HOUSTON LIGHTING & POWER COMPANY
CITY PUBLIC SERVICE BOARD OF SAN ANTONIO
CENTRAL POWER AND LIGHT COMPANY
CITY OF AUSTIN, TEXAS
DOCKET NO. 50-498
SOUTH TEXAS PROJECT, UNIT 1
AMENDMENT TO FACILITY OPERATING LICENSE

Amendment No. 2
License No. NPF-76

ATTACHMENT TO LICENSE AMENDMENT 1.1. 2

Figure 5.6-1

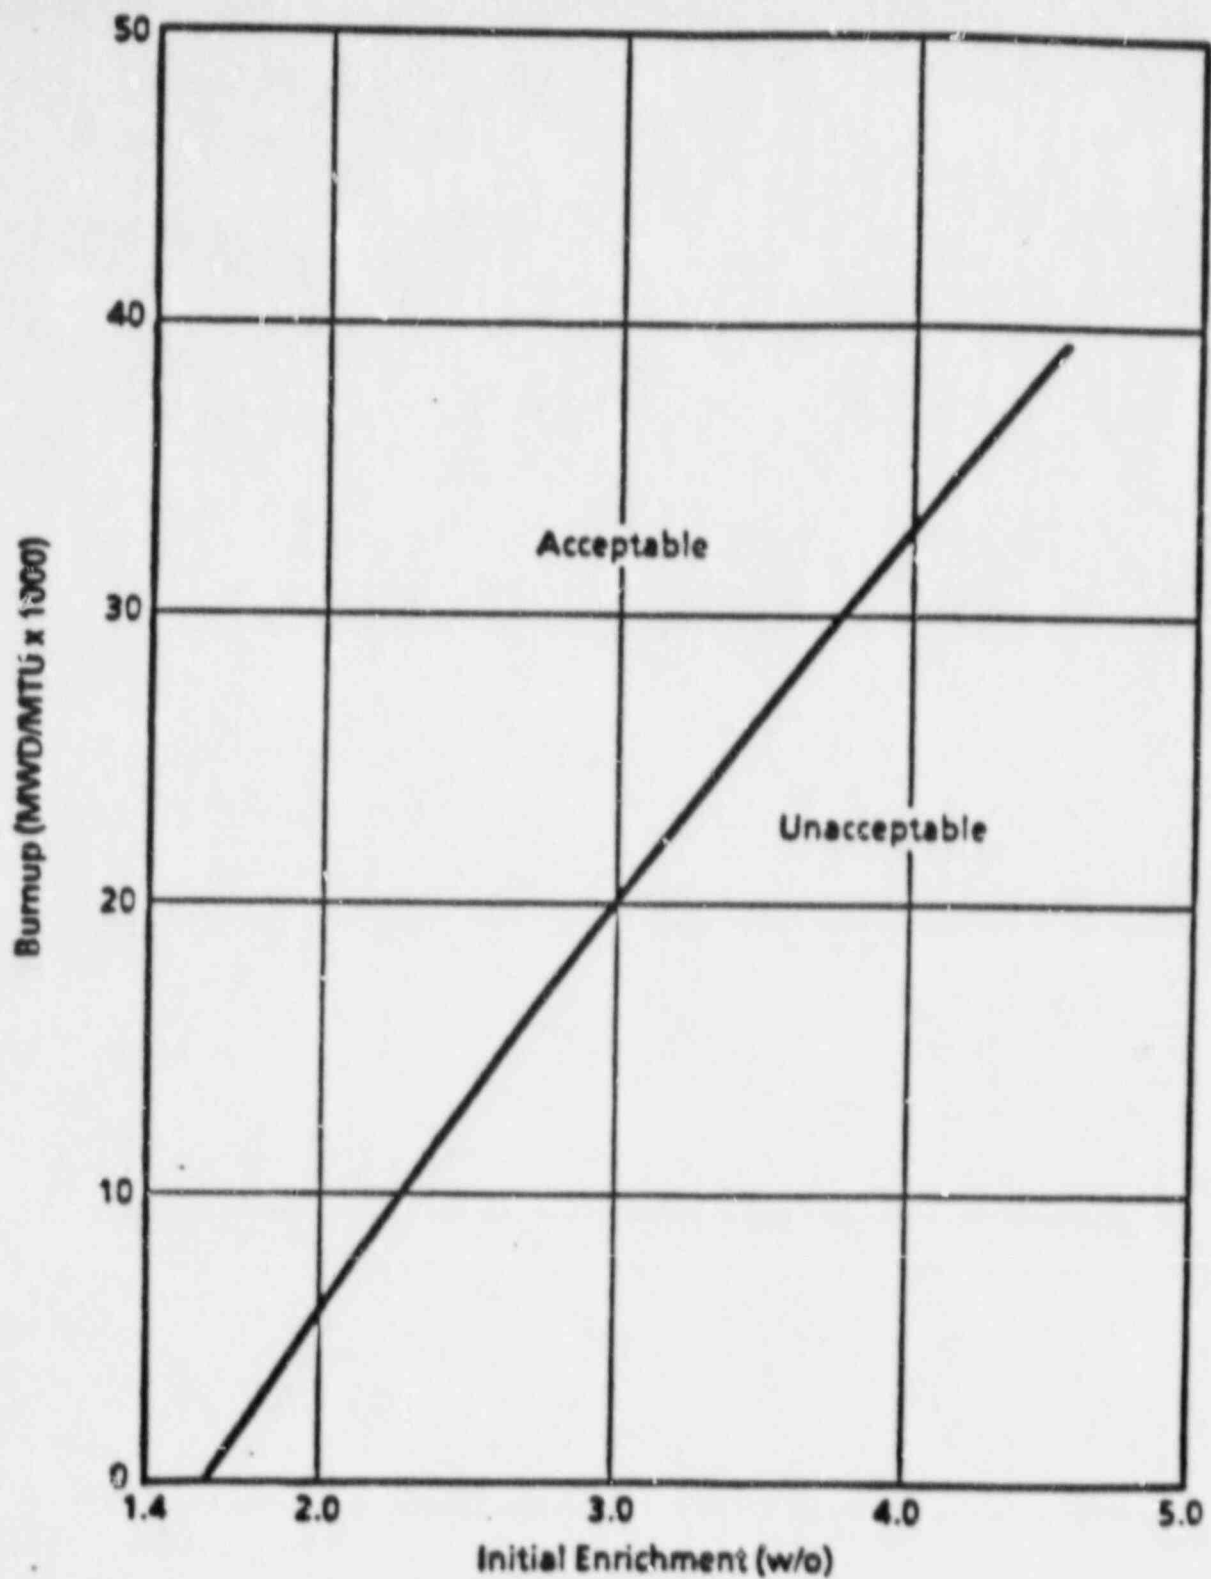
- b. A nominal 10.95 inches center to center distance between fuel assemblies in Region 1 of the storage racks and a nominal 9.15 inches center to center distance between fuel assemblies in Region 2 of the storage racks.
- c. Neutron absorber (Boraflex) installed between spent fuel assemblies in the storage racks in Region 1 and Region 2.
- d. Region 1 of the spent fuel storage racks can be used to store fuel which has U-235 enrichment less than or equal to a nominal 4.5 weight percent. Region 2 can be used to store fuel which has achieved sufficient burnup such that storage in Region 1 is not required. The initial enrichment vs. burnup requirements of Figure 5.6-1 shall be met prior to storage of fuel assemblies in Region 2.
